TUSCAN OAKS DEVELOPMENT
MASTER DEVELOPMENT PLAN

The City Staff Development Review Committee has reviewed Tuscan Oaks Master Development Plan (MDP). Please note that your plan was not accepted, based on the following:

Master Development Plan: 2/11/2005

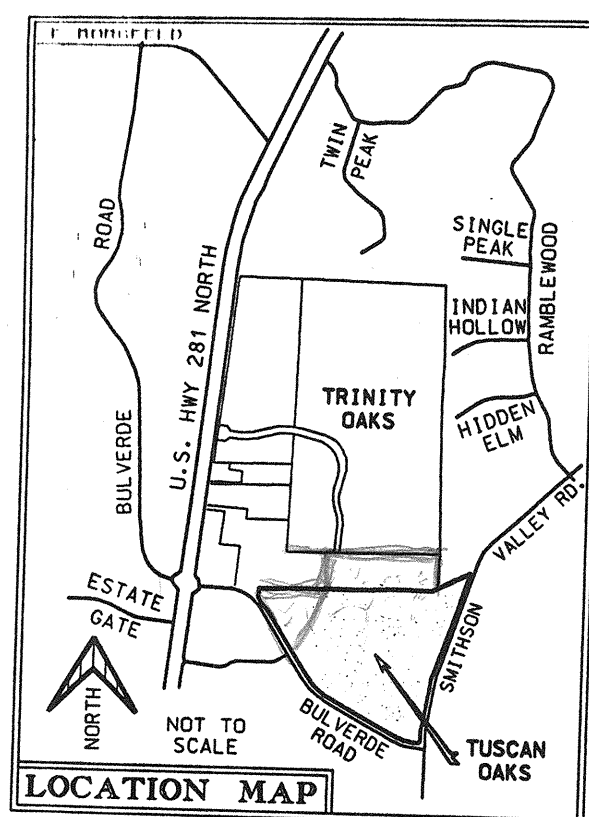
6. REMOVE ~~BE~~ SIGNATURE BLK FOR THE PLANNING COMMISSION

7. REMOVE U.3, U-3A FROM "PHASE 1, PRE-ANNEXATION LAND USE PLAN."
(E) AND RETOTAL

Comments: UNITS 3, 3A STREETS WILL HAVE TO BE LABEL AS LOCAL "A"
50' R.O.W. 35-B101 GENERAL, APPENDIX A (LOCAL A, STREET)
AND 35-B101(C) F(9), TRINITY OAKS P.U.D. # 03-021A WILL HAVE TO BE
AMENDED TO PROVIDE PROJECTION OF STREET INTO TUSCAN OAKS.
THE PLAN IS SHOWING ROADWAYS TO BEHAVE 32' R.O.W.
UNIT #5 ROADWAY REQUIRE TO BE TO COLLECTOR CONVENTIONAL CLASSIC 35-506(C)(1) SYSTEM TABLE 506-2
THE UNIT #5 DOES NOT MEET THE CONNECTIVITY RATIO OF 1:20 35-506(E)(1)
SHOW DENSITIES 35(B101(C) F(11), 35-B101(C) F(24)
SHOW DEVELOPMENT PHASING SCHEDULE INCLUDING SEQUENCE FOR EACH PHASE.
35-B101(C) F(17)

PROVIDE SIGNATURE BLOCK. 35-B101(C) C(1)

- 1. Connectivity Ratio for the MDP is 1.0, require 2. as per UDC 35-506 (e)(1)**
- 2. Remove unit-3 and 3A, PUD from the plans, PUD should be included with the Trinity Oaks Amended PUD, not with the MDP.**
- 3. Label the Limits of the PUD.**
- 4. Put note stating: "Flood Plain will be platted with Unit - 5".**
- 5. Take out of the General Notes, Line # 9.**
- 6. Remove the signature Blk for the Planning Commission.**
- 7. Remove U-3 and U-3A from " Phase 1, pre-annexation land use plan" (E) and re total quantities.**
- 8. Remove U-3 and U-3A from Ultimate Land Use Plan and correct quantities.**

TUSCAN OAKS
MASTER DEVELOPMENT PLAN
N. 847

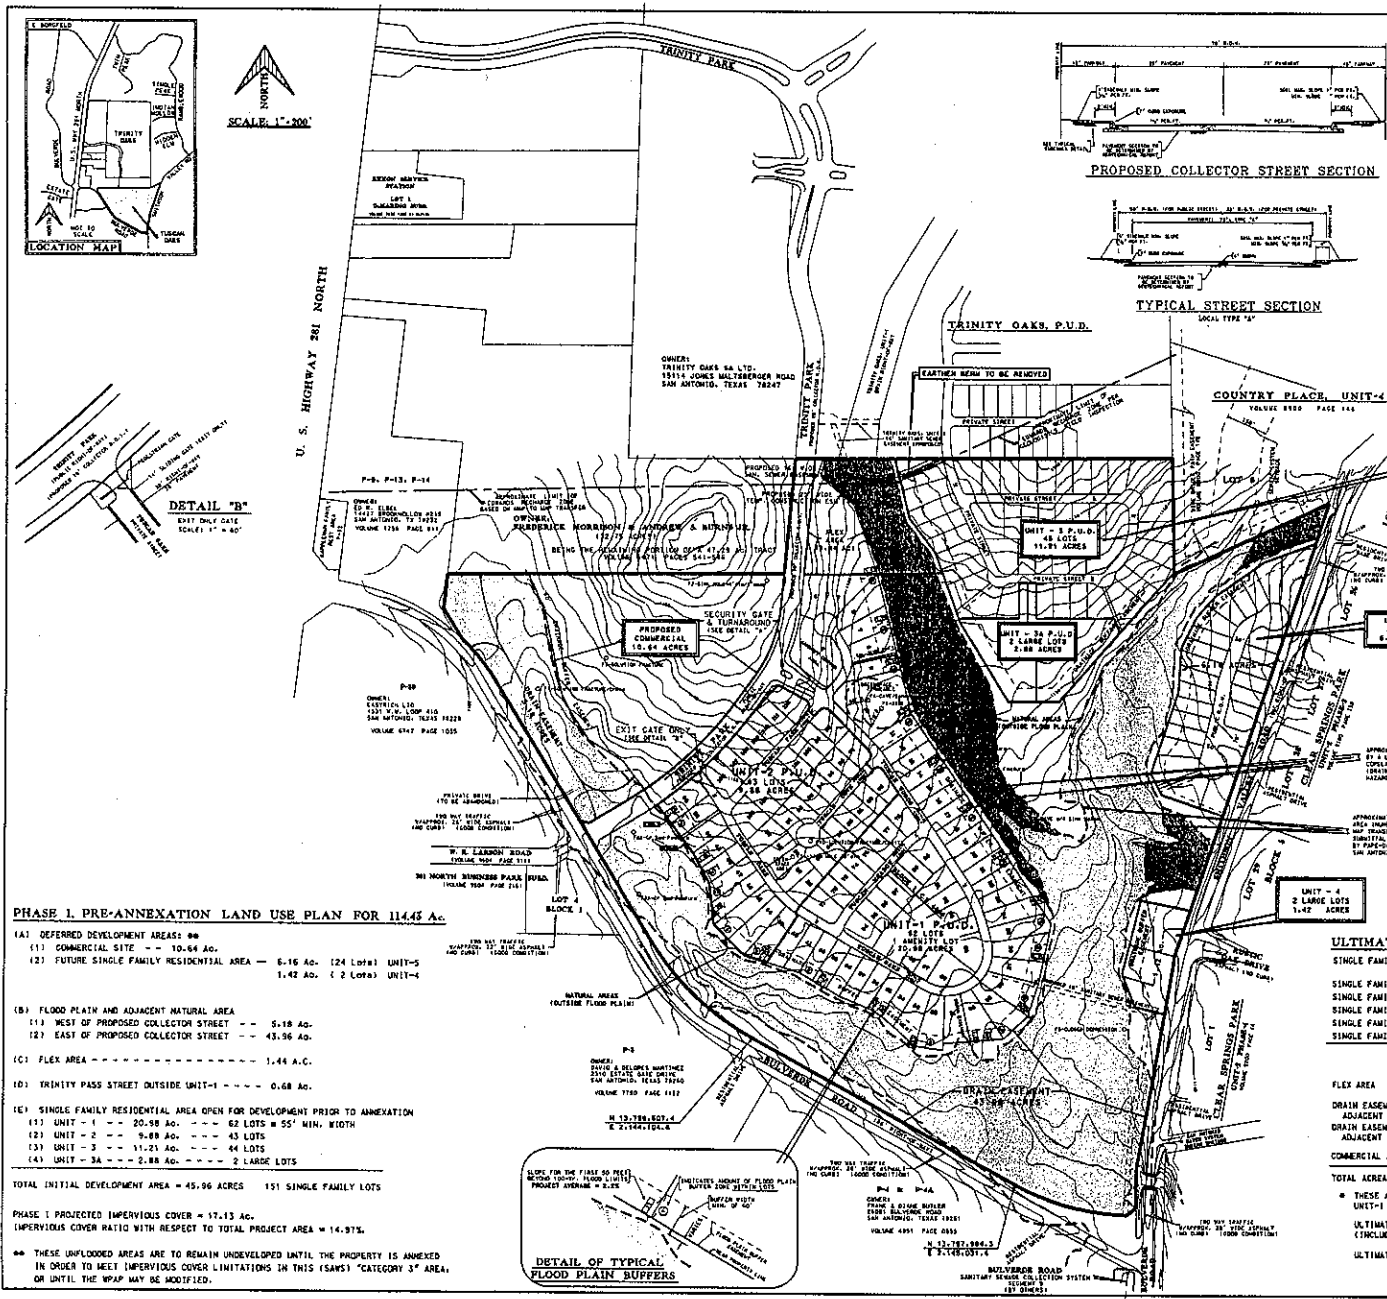
1. Since the submittal did not provide a complete drainage study on the floodplain, please provide signature of owner and engineer on the PUD with the following note.

"The floodplain limits on this Master Development Plan are estimated and subject to change. Approval of subdivision plats associated with this Master Development Plan is subject to the review and approval of Storm Water Management Plan in accordance with Appendix B, Section 35-B119 of the City of San Antonio Unified Development Code."

4. Provide unflooded access (across floodplains) for Units 3 & 3A in accordance with UDC floodplain ordinance. Trinity Oaks MDP requires revisions to include Units 3 & 3A.
